**IN THE MATTER OF** a proposed plan change to rezone land at 611

Rangitikei Line to establish the Whiskey

Creek Residential Area

## ADDENDUM TO SUMMARY OF TRANSPORT REVIEW OF CHRIS ROSSITER (SECTION 42A OFFICER)

## **APPENDIX A**

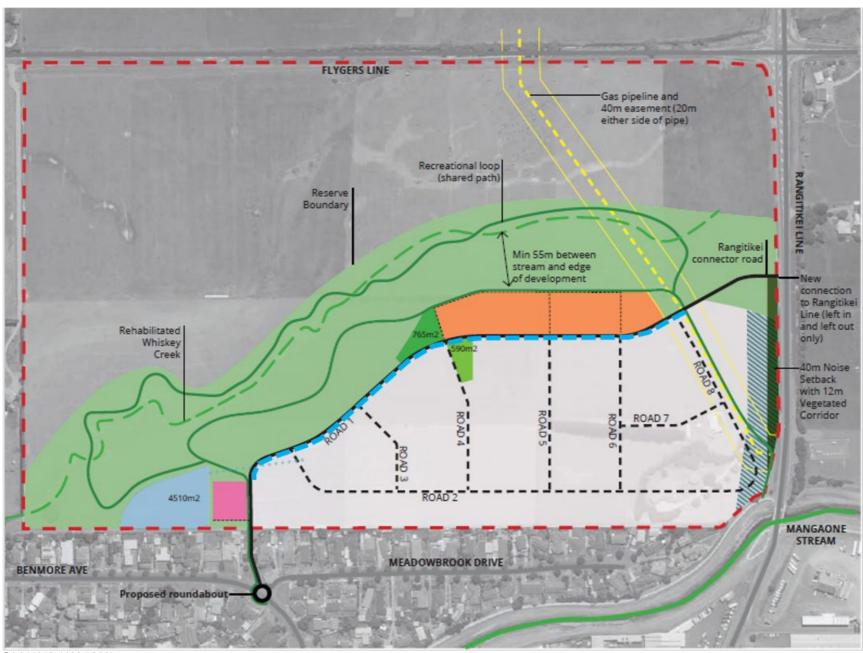
- [3] At paragraph [8] of my summary statement I set out my preference, and related justification, for an off-road shared path along (immediately adjacent to) Road 1 to provide a safer route for cyclists. Since the Applicant does not intend to construct Road 1 with on-road cycle lanes, then I consider that the Structure Plan should include specific provision for an off-road cycle facility beside Road 1.

- [5] The drawing included at **Appendix A** to this addendum shows the amendment I propose to the Structure Plan. The drawing shows the indicative alignment for an off-road cycle facility as a cyan dashed line on the southern side of Road 1 extending between the commercial centre and Road 8. I anticipate that there will be a need for a crossing facility close to the proposed commercial centre that would link to the path already proposed beside Road 1 at that location.

- [6] In my opinion, there is ample width within a 19.2 metre wide corridor (Collector Road standard) for the proposed 6.5 metre wide carriageway and a 3 metre wide shared path on at least one side of the carriageway, plus provision for some parking and landscaping.

[7] I remain of the opinion that there should be a provision in the District Plan to provide for the outcome that I have set out above, as shown in Appendix A.
